DOCUMENT CHANGE REQUEST

Title: Thermistors (thermally Sensitive Resistors) Range 2000 to 100000 Ohms at +25C with a

Number: 4006/014

ESCC Detail Specification No. 4006/014

**FIGURE 2 - PHYSICAL DIMENSIONS**

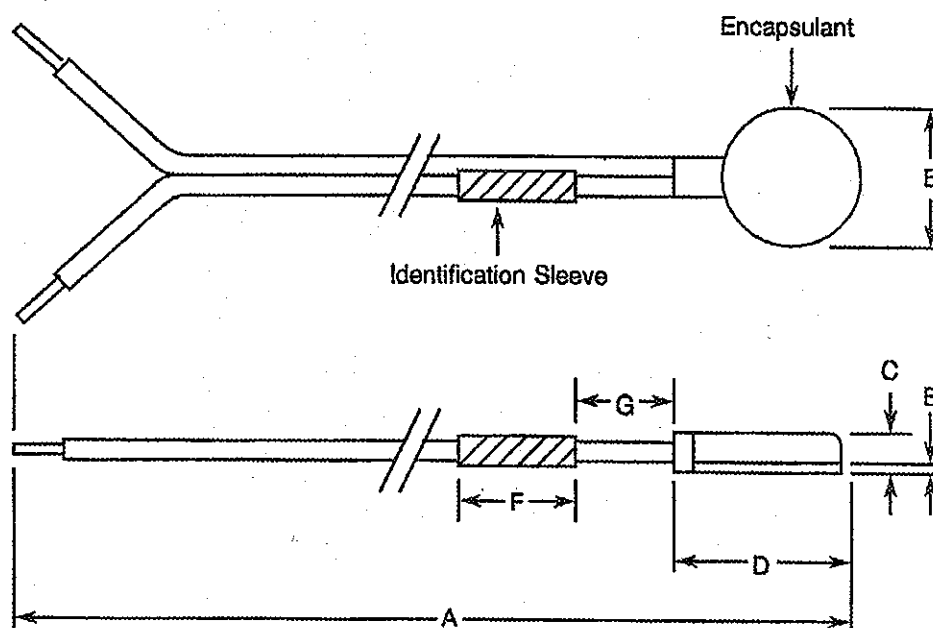
4. Thermal shock conditions changed to meet the maximum operating temperature.
5. Physical dimensions, weight and lead material changed for Variant 06.
6. Test temperature tolerance changed to +/- 0.01°C to meet current manufacturing practices
7. Table 2 updated for Variant 06.
8. Table 6 updated to include only valid endurance tests.

4. Thermal shock conditions changed to meet the maximum operating temperature.
5. Physical dimensions, weight and lead material changed for Variant 06.
6. Test temperature tolerance changed to +/- 0.01°C to meet current manufacturing practices.
7. Table 2 updated for Variant 06.
8. Table 6 updated to include only valid endurance tests.

SYMBOL	MILLIMETRES			
	VARIANTS 01 - 05		VARIANT 06	
	MIN	MAX	MIN	MAX
A	280.00	330.00	356.00	406.00
B	6.10	6.60	6.10	6.60
C	-	2.80	-	2.40
D	-	9.80	-	9.80
E	0.33	0.48	0.33	0.48
F	-	50.00	-	50.00
G	50.00	80.00	50.00	80.00
